<b>JRPP No.</b>	2011HCC027
<b>DA No.</b>	DA249/2010.2
<b>Local Government Area</b>	Singleton
<b>Proposed Development</b>	Section 96 Amendment - Refurbishment and extension of Gowrie Street Mall
<b>Property Address</b>	Lots 162 & 103 DP 635677, Lot 11 DP 592595, Lot 1 DP 194663, Lot 8 DP 666536, Lot 3 DP 973029, Lot 4 973028 and Lots 210 & 211 DP 1037874; 1 Gowrie Street SINGLETON
<b>Applicant</b>	Charter Hall REIT
<b>Number of Submissions</b>	Six – Five against, One in support
<b>Recommendation</b>	Approval with conditions
<b>Report By</b>	Alison Clark

## **Executive Summary**

The Section 96 application seeks to modify deferred commencement conditions AA1 and AA2 imposed by the Hunter and Central Coast Joint Regional Planning Panel on 17 March 2011.

DA10 C

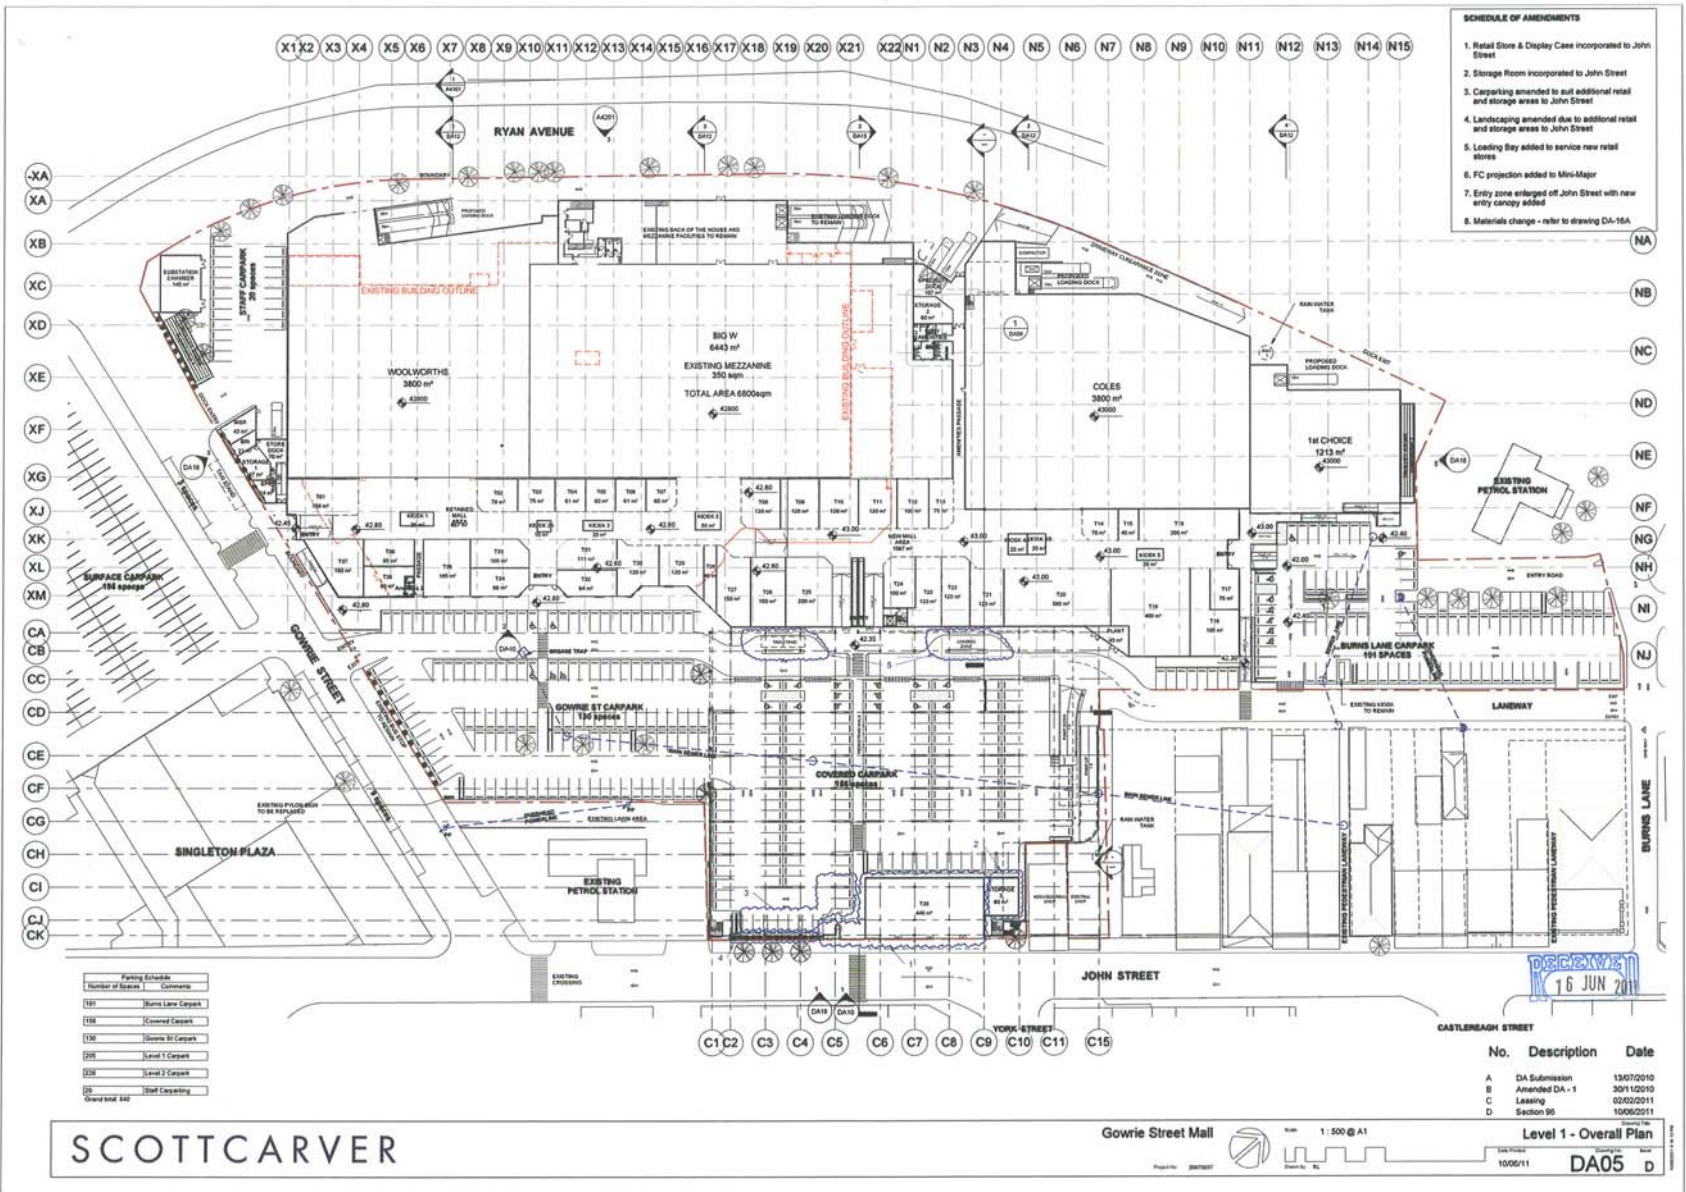
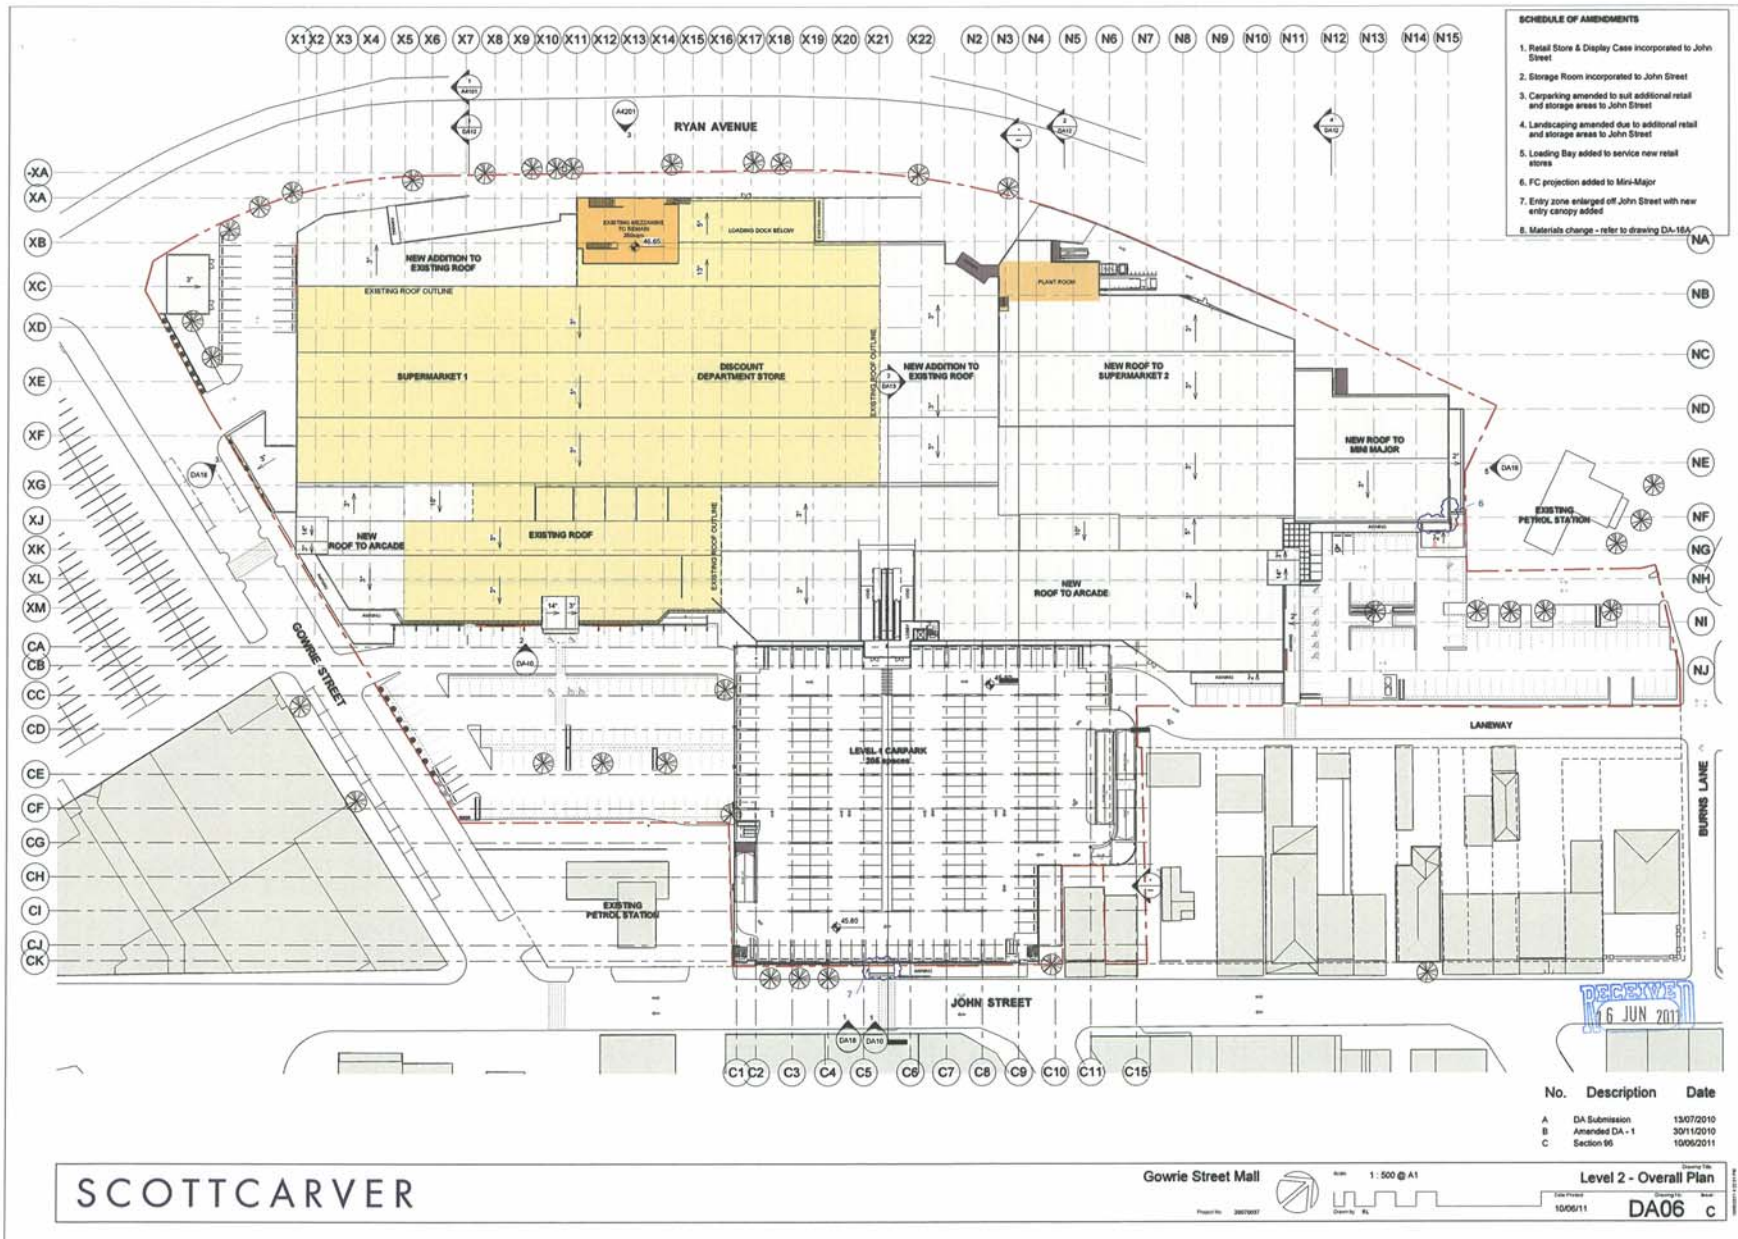
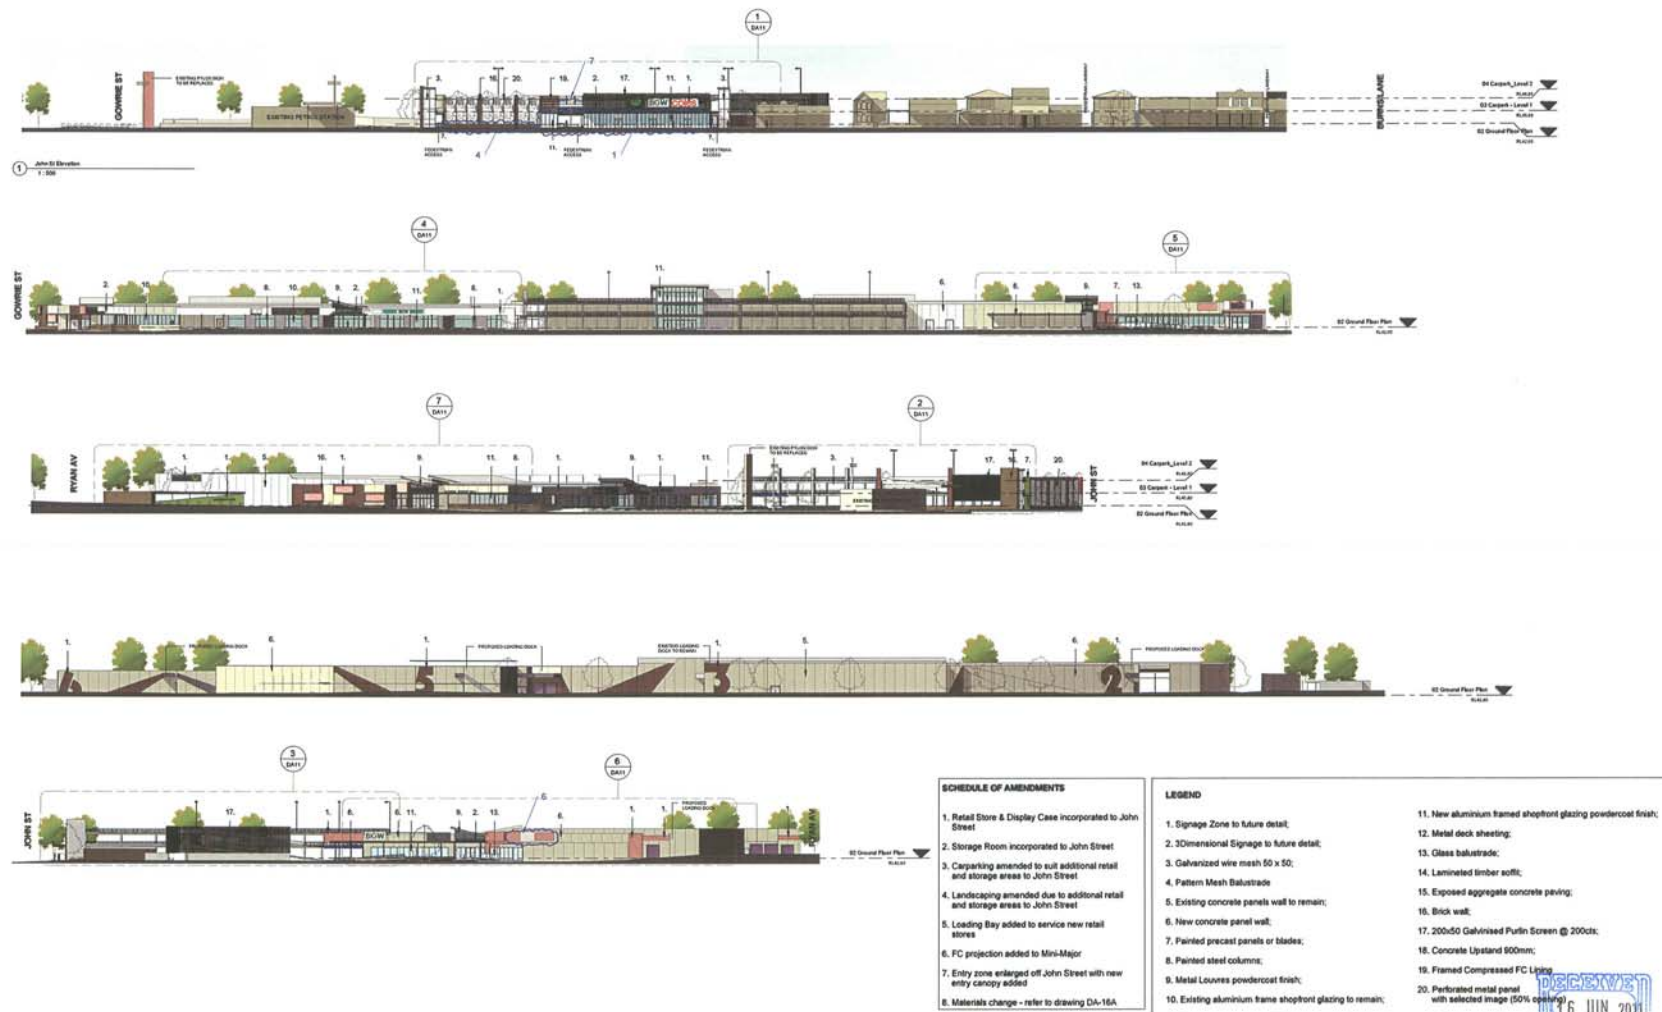
Signage is proposed above the specialty retail. The signage will provide an identification element to the façade and will assist with way finding into the development. The signage shown on the plans is considered excessive and tends to dominate the streetscape. Condition H4 in the original consent required a separate approval for any advertising signage and a full assessment will be undertaken at this stage.

The southern end of the John Street frontage has been treated with passive design features as it is a less active area. The metal mesh panel screening has been designed with a variety of perforation sizes to create patterning and varying degrees of light and movement.

In addition to this a showcase area is incorporated into the car parking structure. This area will be used for retailers inside the store to display wares on John Street. The show case area is highlighted with a painted feature above to add further interest to the façade. The showcase area gives the impression of an active retail space without actually providing leasable shop area.

A masonry plater box is proposed along the remainder of the John Street frontage. The alignment of the landscaping has been amended slightly to align to the formal geometry of the car parking structure. A hedge is proposed along this section of the car park in an attempt to enhance the streetscape whilst still allowing for passive surveillance of the area. Landscaping, with the exception of street trees, is not common in John Street with the area characterised by shop fronts. The landscaping does not activate the street front, is inconsistent with the existing urban design characteristics of John Street and is not considered suitable in this location.

Whilst the southern portion of the John Street frontage is not a highly trafficked area it still requires activation and the landscaping proposed does not achieve this. An extension of the showcase area in lieu of the landscape planting would provide the street activation required. The showcase is an innovative way of providing activation to the street and delivering a better urban design outcome without providing retail floor space. Condition C14 has been included in **APPENDIX A** requiring amended plans to be submitted to Council reflecting the extension of the showcase area as detailed above. In addition to this the street awning should also be extended along the southern portion of the site to increase user amenity. The street awning also provides a positive contribution to the streetscape.

- Extension of the showcase area to replace the proposed masonry planter boxes and landscaping along the southern portion of the John Street frontage,
- Provision of a street awning to the entire John Street frontage,
- Continuation of the upper level façade treatment shown on the northern portion of the façade along the southern portion of the façade.

- C14** The design is to be modified to include a showcase area and street awning along the southern section of the site's John Street Frontage. The upper levels of the car park façade are to be provided with the same façade treatment as the northern portion of the frontage. Prior to the issue of a Construction Certificate amended plans are to be submitted for the approval of Council's Director Planning and Regulations.
